**Date:** ~~April 25, 2024~~ ~~November 19, 2024~~ ~~March 14, 2025~~  
**To:** Aditya Jatar, BOE  
**CC:** Kaylie Coleman, Bryan Golden,  
Transportation and Public Works Department  
**Reference:** **200 E Riverside PUD Traffic Impact Analysis** (C814-2023-0057) – 200 E Riverside Dr,  
Austin, Final Memo

**Summary of the Transportation Impact Analysis (TIA):**

Figure 2. Improvement Extent

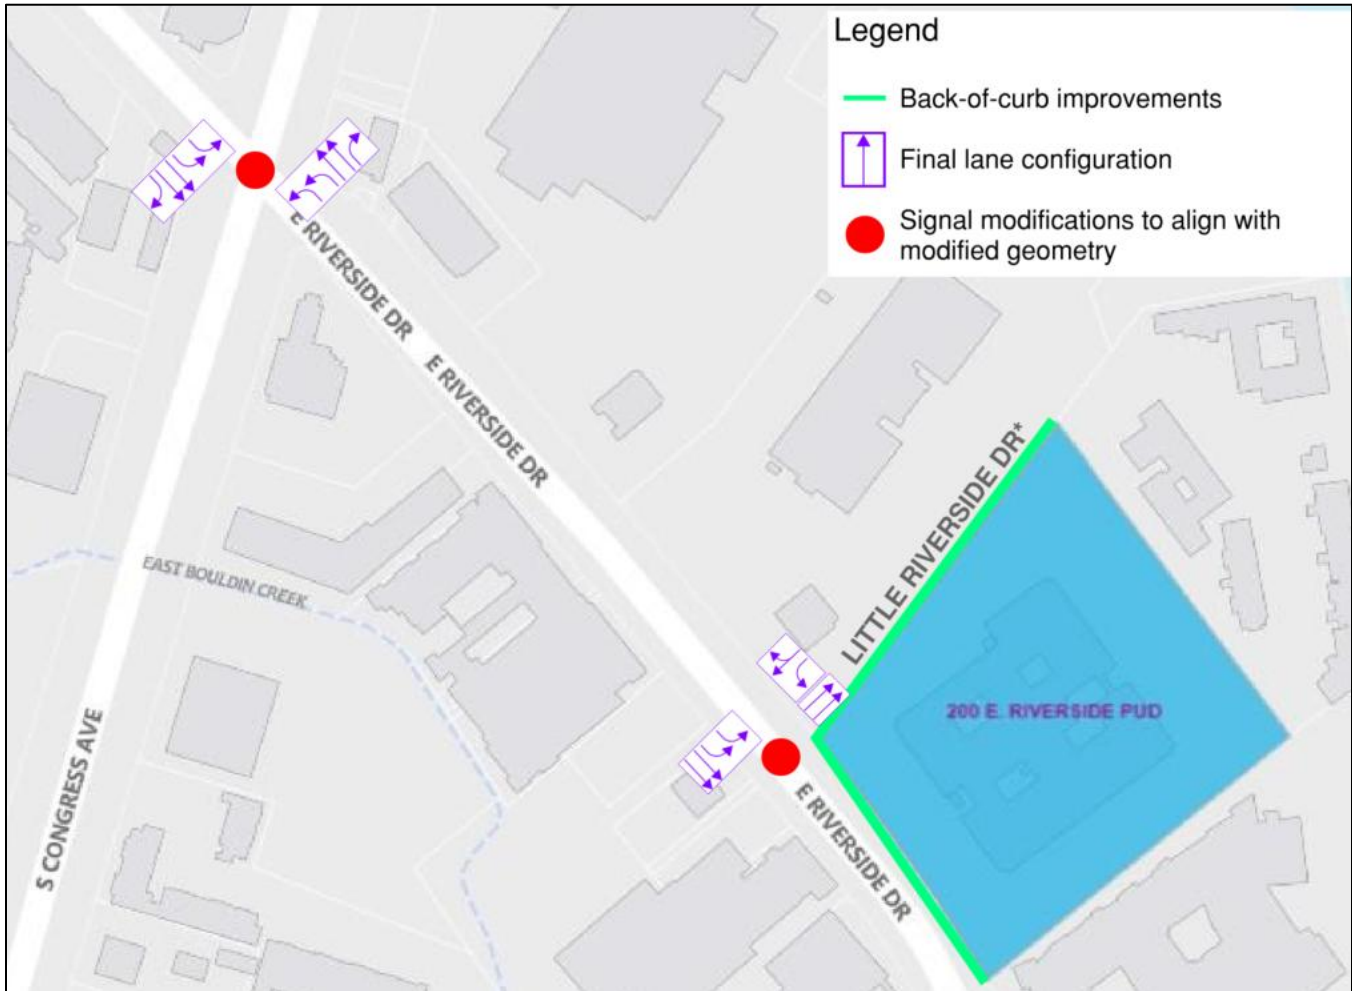
<i>Table 2. Improvements Identified in the TIA</i> <i>(This will be reevaluated at the time of the site plan when more information about the site and Project Connect is available.)</i>	
<b>Name</b>	<b>Improvement</b>
E Riverside Dr & Little Riverside Dr* (See Figure 2 for the improvement extent)	Restripe existing pavement to 1L, 1 TR along SB Little Riverside Dr* approach to accommodate SB LTL on Little Riverside Dr*
	Provide 1 additional LTL to create dual left turn lanes along EB approach
	Widen NB approach with merge taper along Little Riverside Dr* to provide additional receiving lane for EB to NB dual left turns
	Signal re-timing, lane assignment sign, signal head modification as needed to align with modified geometry
E Riverside Dr & S Congress Ave (See Figure 2 for the improvement extent)	Install 1 additional LTL to create dual left turn lanes along EB E Riverside Dr approach
	Install 1 additional LTL to create dual left turn lanes along WB E Riverside Dr approach

Install 1 RTL along WB E Riverside Dr approach
	Signal re-timing, lane assignment sign, signal head modification as needed to align with modified geometry
Back-of-curb Improvements (See Figure 2 for the improvement extent)	Design and construct back-of-curb improvements with the coordination of TPW along site frontages on Little Riverside Dr* & E Riverside Dr
